## Master Traffic Impact Study

comments provided on 03/06/23 seg

## Fitzsimons Innovation Cam Aurora, Colorado

FIGURE 7

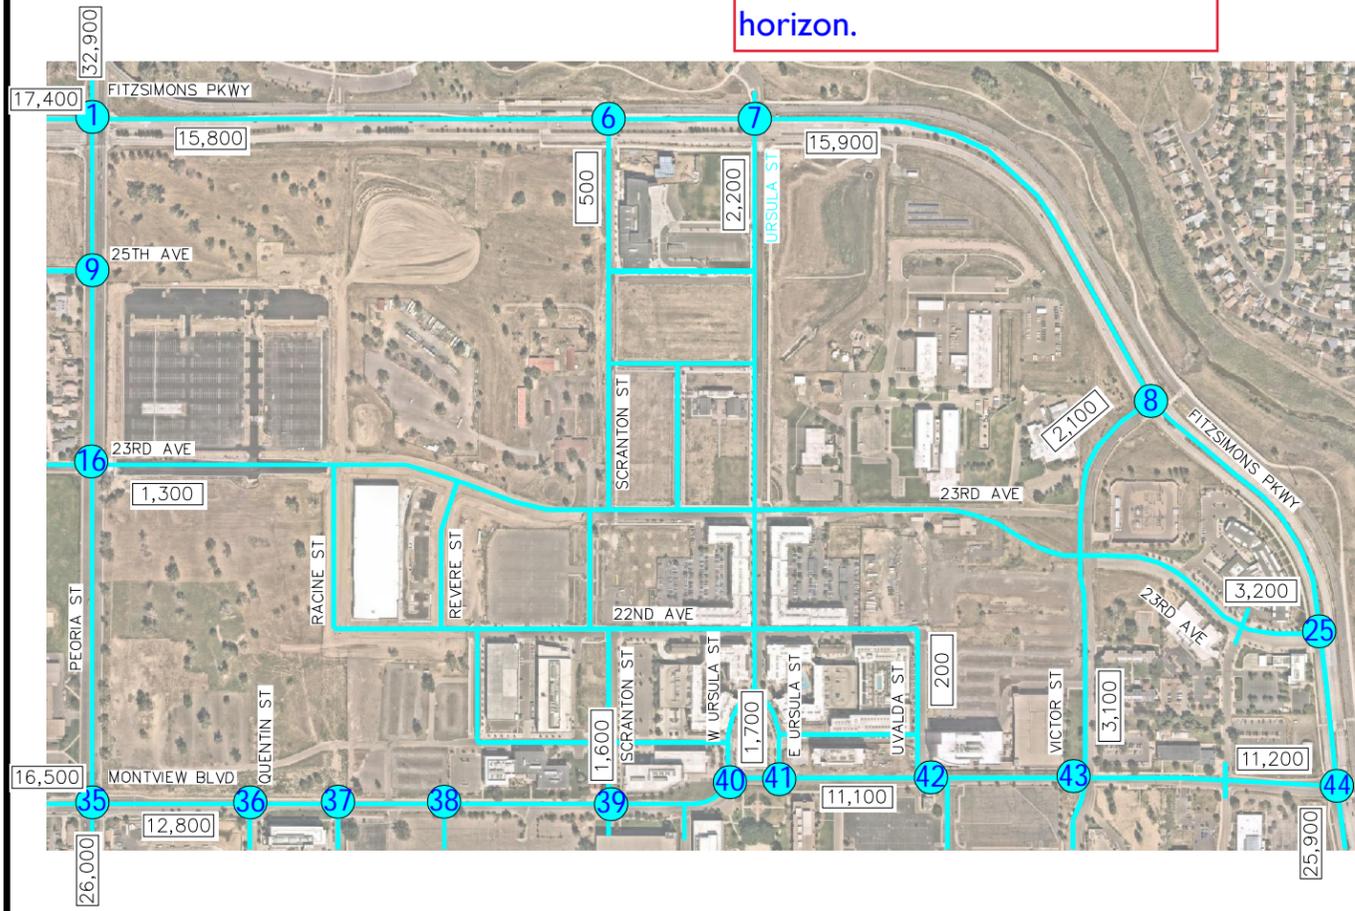
verify 0.5 growth factor was applied to 2022 ADTs to get 2040 ADTs

These traffic volumes were verified that they do grow with the 0.5% annual growth rate. Some minor variation in this exact actual growth rate may occur due to the balancing of volumes between intersections that was conducted for the 2040 horizon.

FIGURE 9

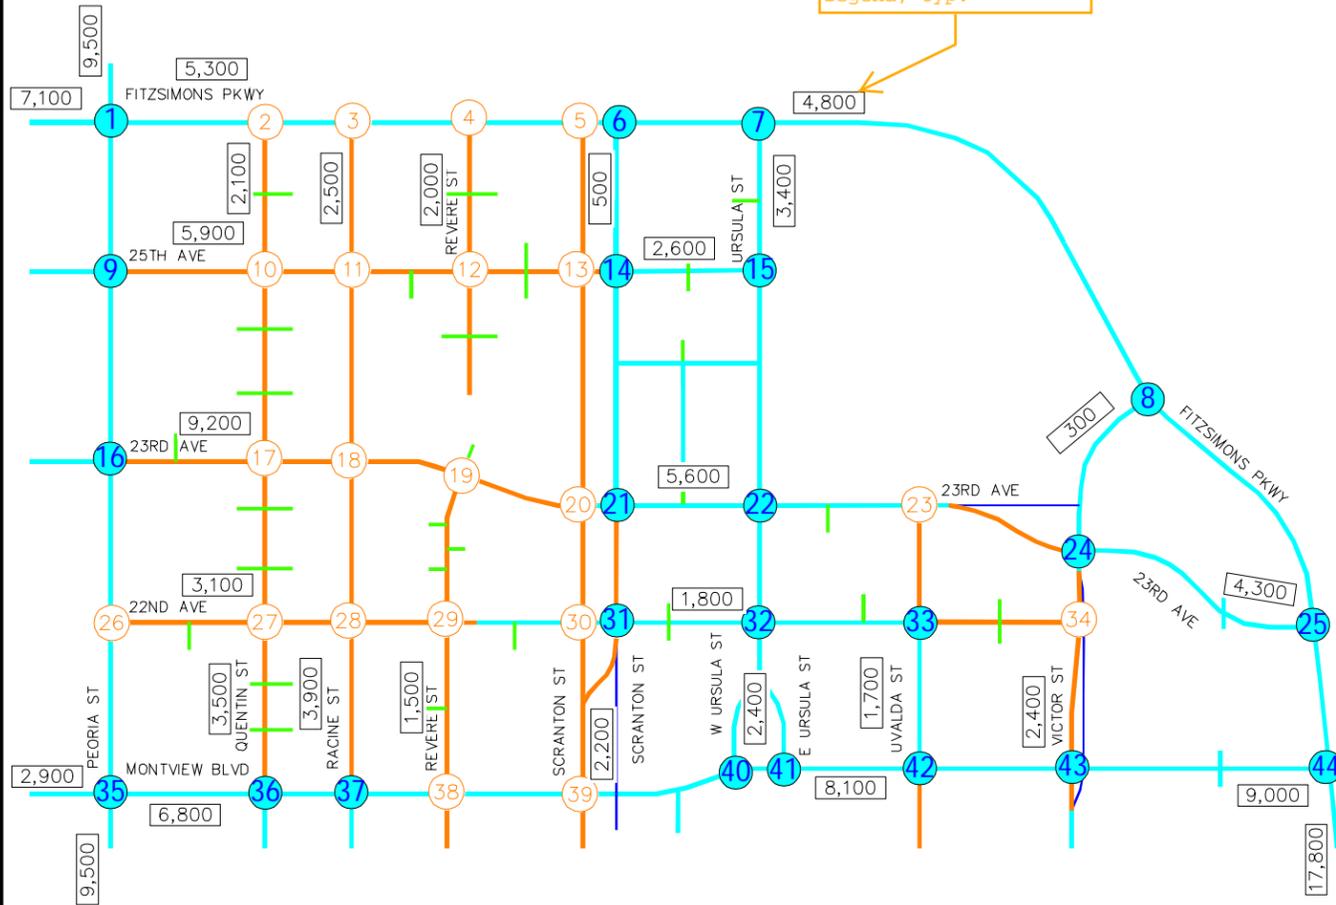
add ADT callout to legend, typ.
